Murphy Aircraft Mfg. Ltd.

Service Bulletin: 161120SR

SR2500 Front Wing Attachment Spacers

FIGURE 1

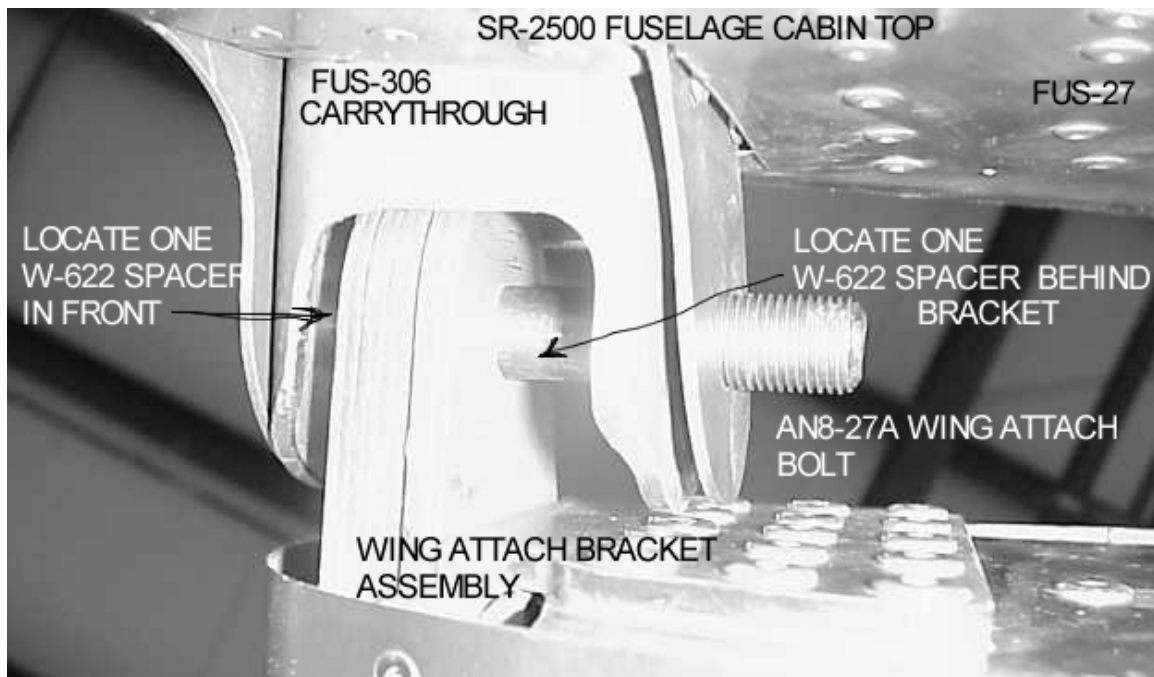
The forward wing attach points of the SR2500 wings are retained by the fuselage FUS-306 top carrythrough ends using a single bolt. Fore and Aft movement of the wing attach bracket assembly, along the axis of the attach bolt must be prevented.

To prevent this movement two W-622 spacers are used with one being placed on either side of the wing attach bracket assembly as shown in figure 1 below.

The W-622 Delrin spacers prevent fore / aft movement of the wing and prevent the rear wing attach brackets from being over stressed from such movement. The spacers also prevent the ears of the FUS-306 carrythrough from being distorted or compressed during the bolt tightening process, weakening them. Four W-622 spacer blocks are now provided with newer SR2500 kits. The builders of older kits not provided with these spacers may contact our shipping department for an upgrade. Alternately, stacked AN washers may continue to be used as on earlier kits. The W-622 spacers are thicker than required for this purpose and can be filed and sanded down to fit exactly the dimensions of each installation.
